# The Association for the Conservation of Energy (ACE) Response to the Renewable Heat Incentive

## Consultation on the proposed RHI financial support scheme

#### Where does our heat currently come from?

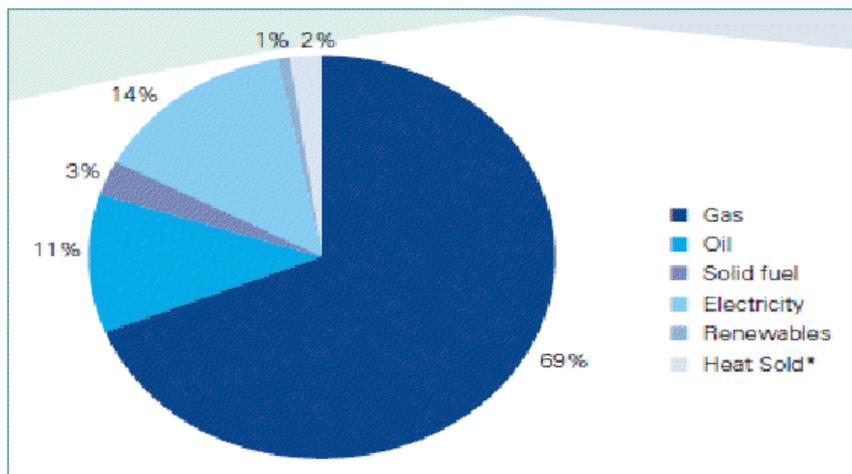
efficient gas fired heating system, for example solar thermal providing base water heating). Government's own figures (Appendix 1) illustrate that 29% of the UK's heat comes from fuels that are neither gas nor renewable. This reveals that there are more than enough properties and businesses using non-net gas that could take up the RHI to meet the 15% renewables target, with a far greater amount of carbon being saved.
